Re: Bayer MaterialScience LLC  
125 New South Road – Hicksville, New York  
USEPA ID#: NYD002920312  
BBL Project #: 2302.32303 #5

*Demolition Work Plan*

**Bayer MaterialScience LLC  
125 New South Road  
Hicksville, New York**

**ATTACHMENT 1  
MODIFICATION TO THE DEMOLITION WORK PLAN**

FIGURE  
**1**

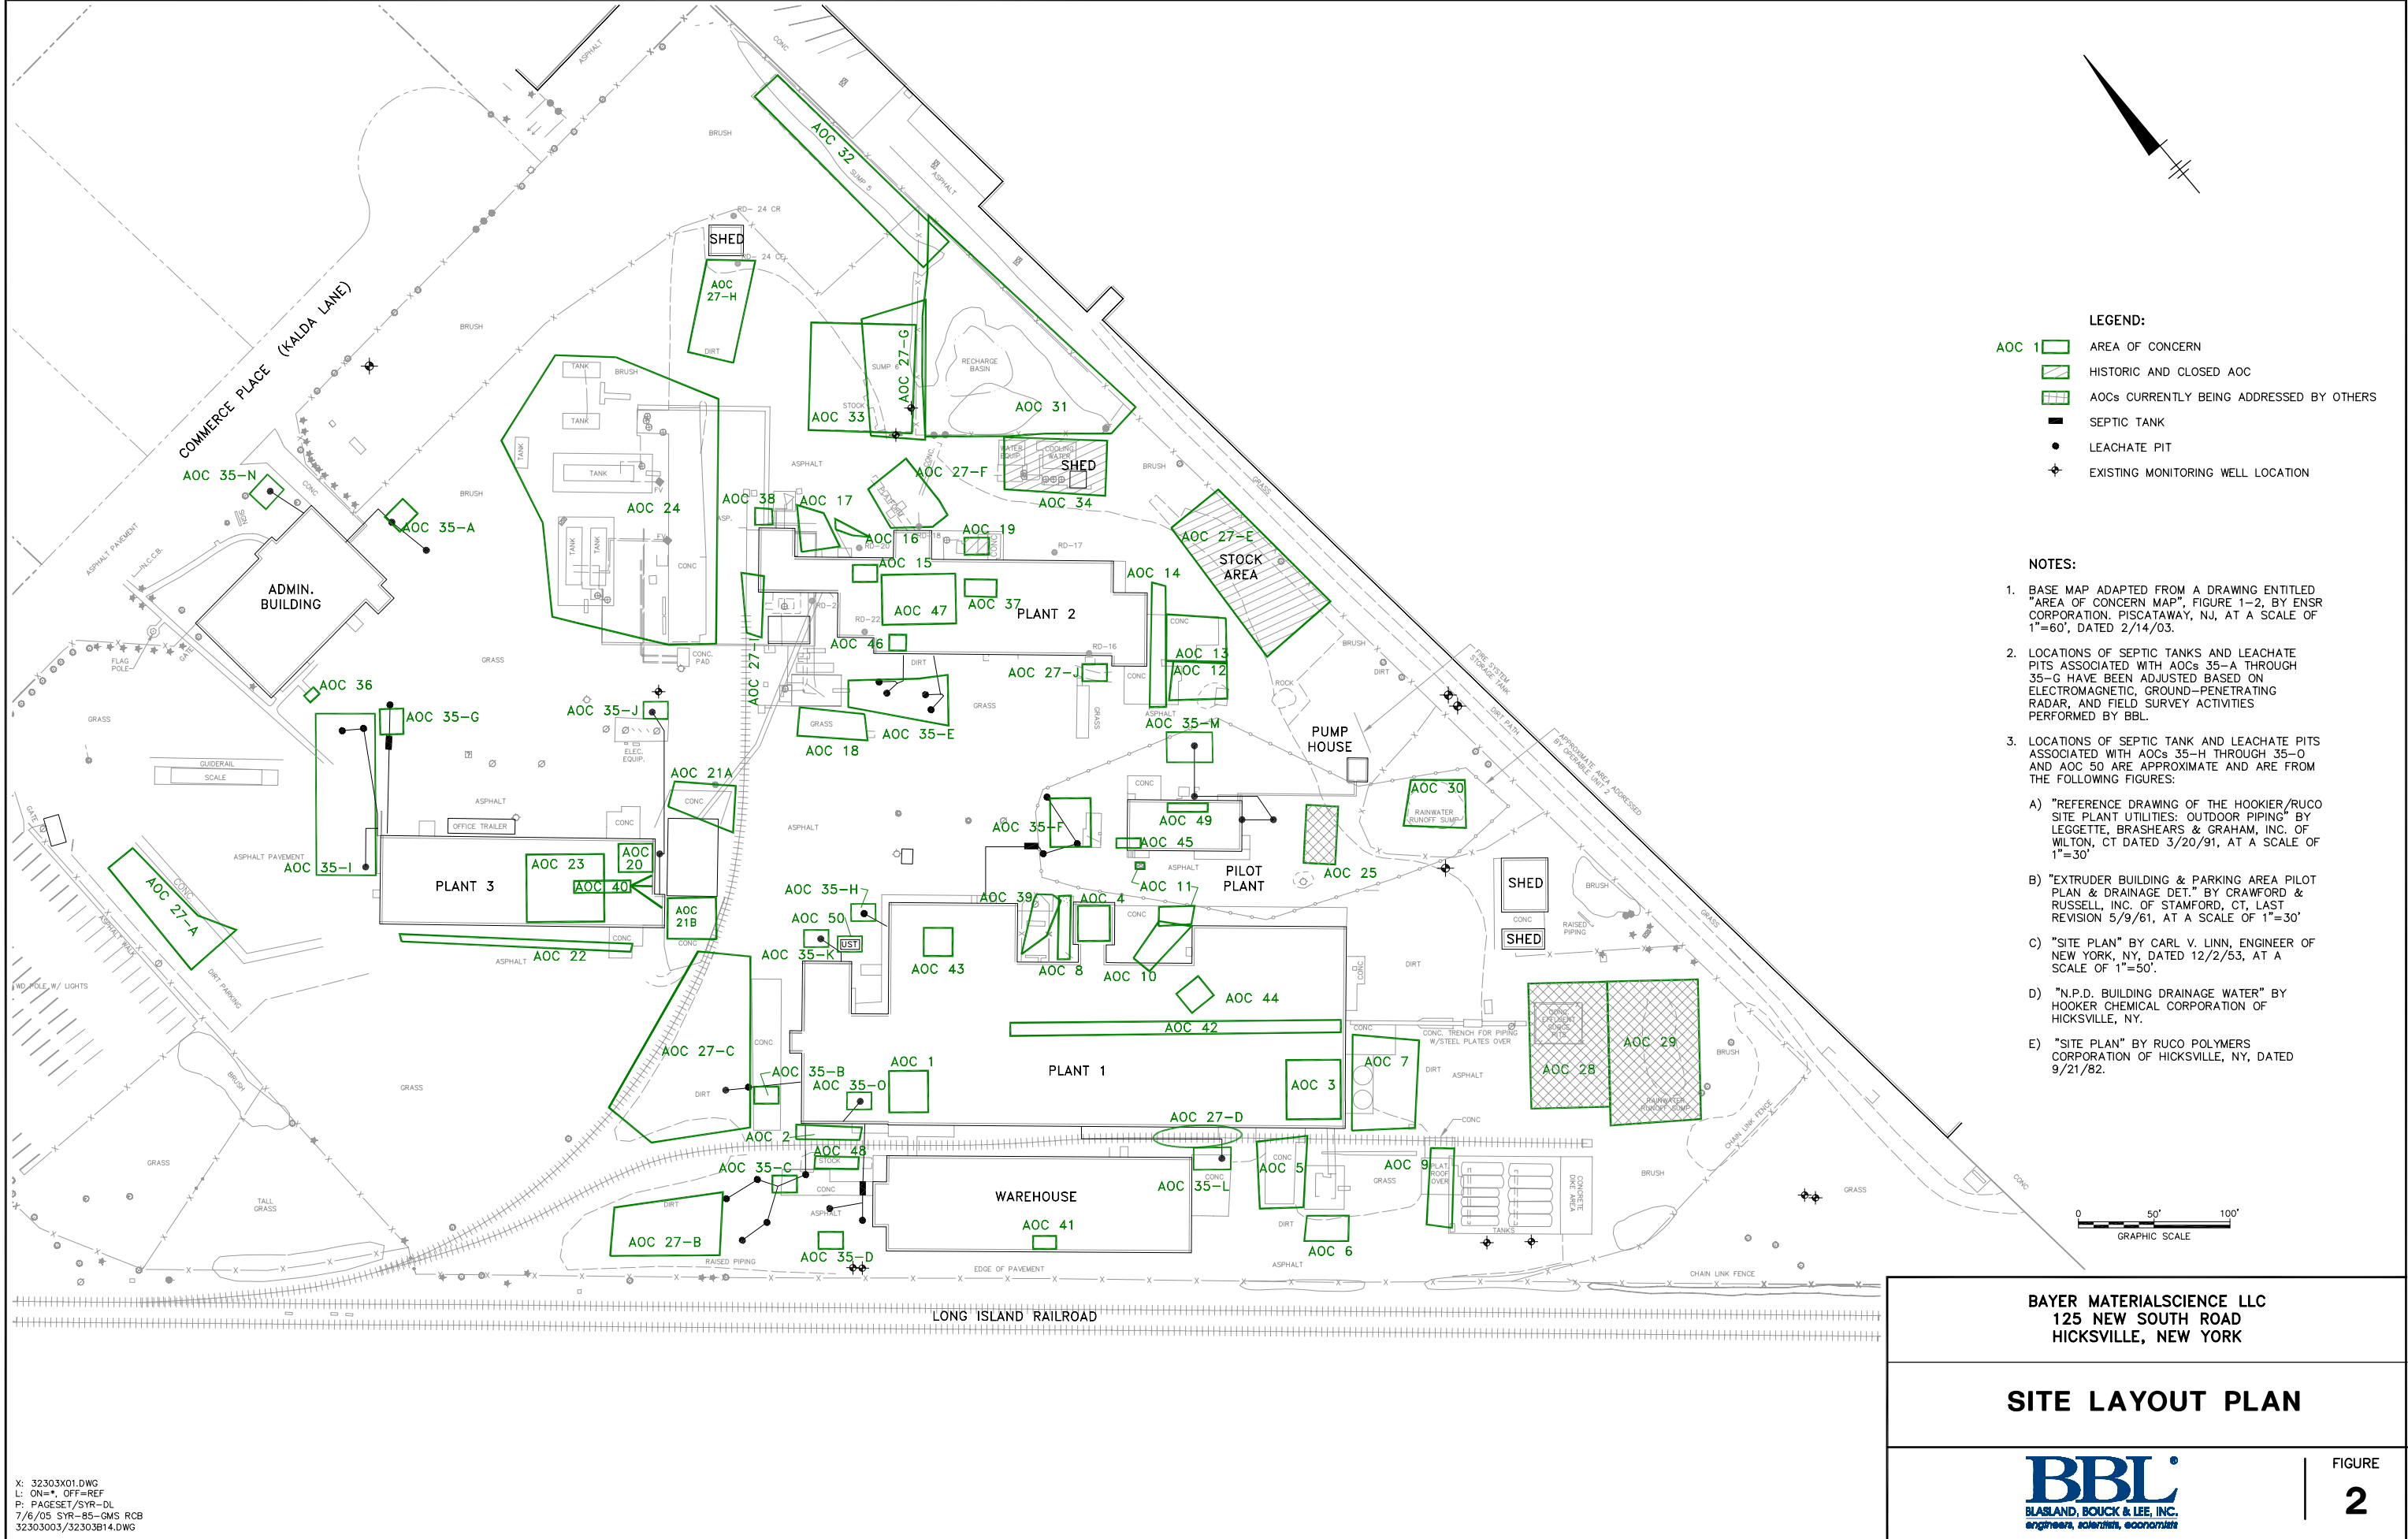
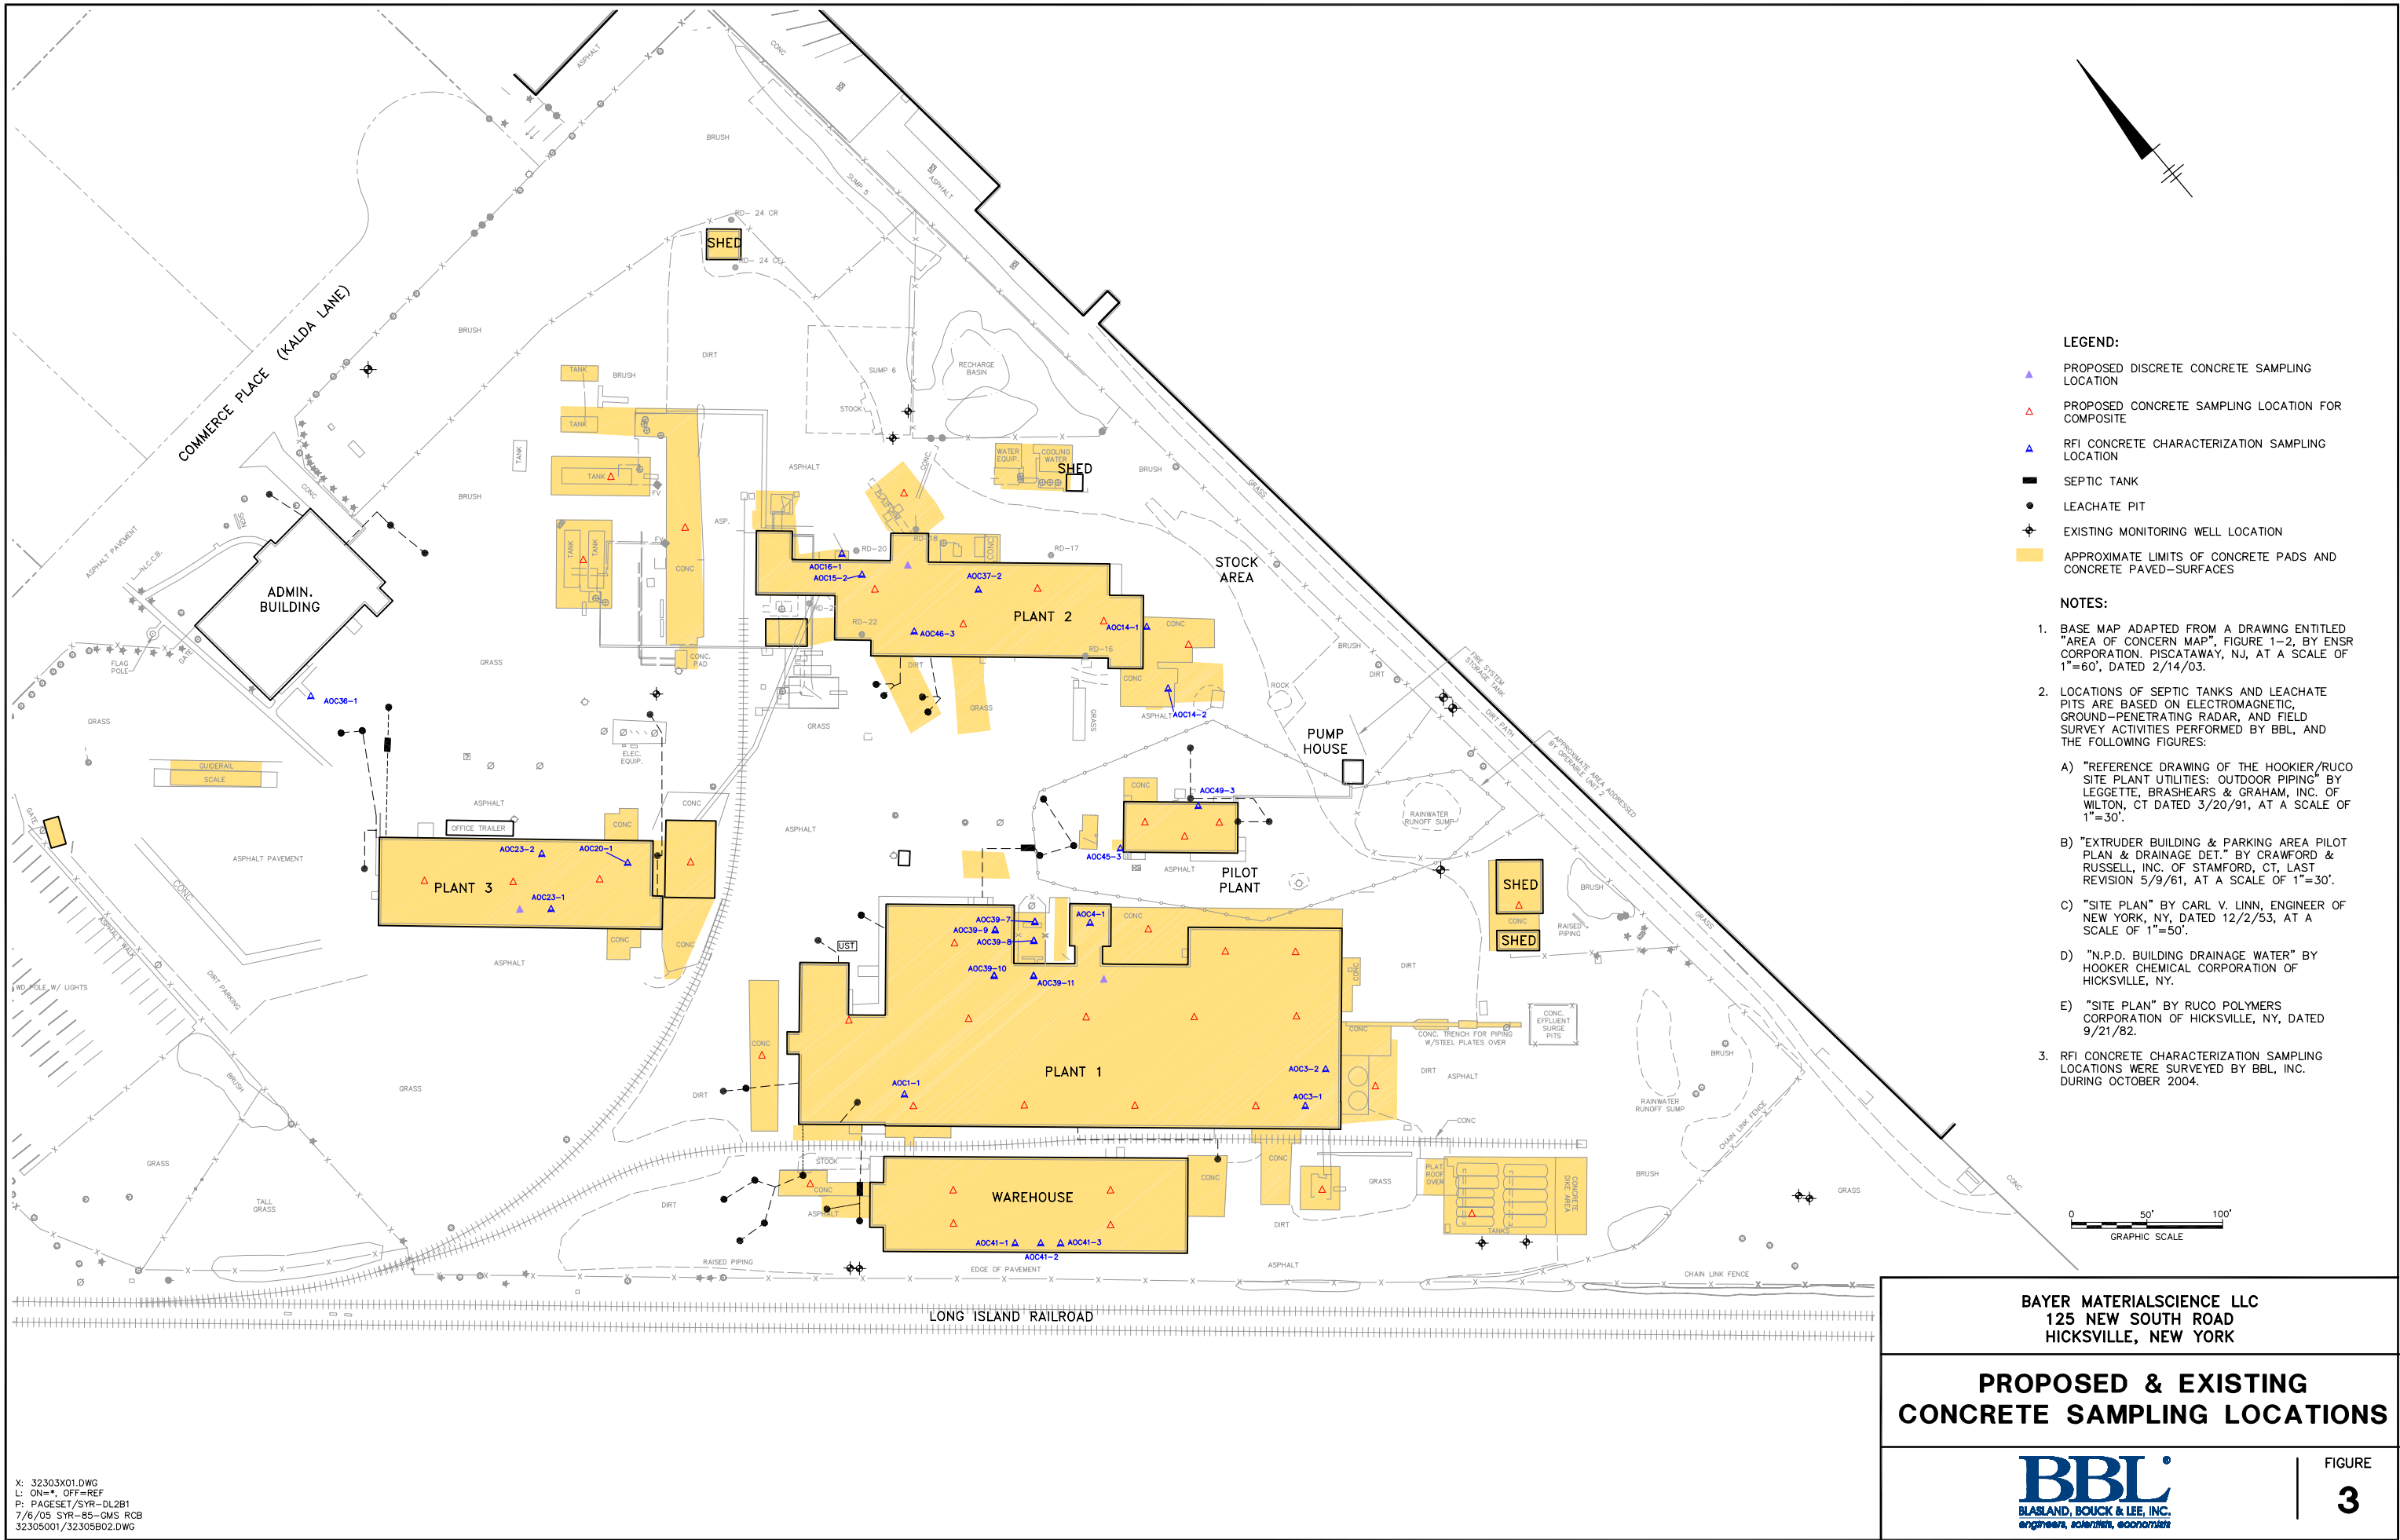
***Comment 1***

Additional discrete and composite concrete core samples will be collected to further evaluate the presence and extent of PCBs in the former building concrete floor slabs and concrete-paved areas outside the floor slabs. Under the proposed revised sampling approach, a total of 72 representative discrete samples will be collected (instead of 39 as called for in the Demolition Work Plan). The proposed discrete sampling locations will provide additional coverage across the building floor slabs, coverage in concrete-paved areas outside the slabs where no samples were previously proposed, and coverage in the general areas identified in the table in Subsection 1.3.4 where possible staining/slight staining was noticed by field sampling personnel during the RFI. Discrete samples to evaluate concrete re-use will not be collected from areas where heavy staining is observed, because concrete from such areas will be segregated during demolition for proper offsite transportation and disposal.

Under the revised sampling approach, a total of 12 composite samples will be collected, each formed from four to seven discrete samples. The revised composite sample quantity equates to one composite characterization sample per approximately 310 cubic yards (CY) of concrete anticipated to be generated by the demolition activities. Locations where discrete samples will be collected to generate composite samples are shown as red triangles on the revised version of Figure 3 (see attached PDF file). The purple lines on Figure 3 designate boundaries for each composite sample. As indicated by the purple lines, the actual area of concrete to be characterized by each composite sample is approximately the same (just over 100 feet by 100 feet). An analytical sample summary, which identifies the proposed 12 composite samples, sampling areas, and corresponding number of discrete samples to form each composite, is presented below.

As indicated above, areas of concrete flooring exhibiting heavy petroleum staining will be transported for proper offsite disposal. The approximate areas of concrete flooring exhibiting heavy petroleum staining are shown on Figure 3. Actual limits of stained concrete will be determined based on observations during a reconnaissance in support of the pre-demolition characterization sampling. Bayer had originally planned to collect discrete PCB concrete samples (uncomposed) to evaluate disposal requirements for the heavily-stained concrete. However, upon further consideration and discussion with the NYSDEC during an August 11, 2005 conference call, Bayer may instead elect to first remove the stained concrete and then collect one or more composite samples to characterize the concrete (as-generated) for disposal. Bayer will coordinate with the anticipated disposal facilities to see that the necessary analytical data is provided.
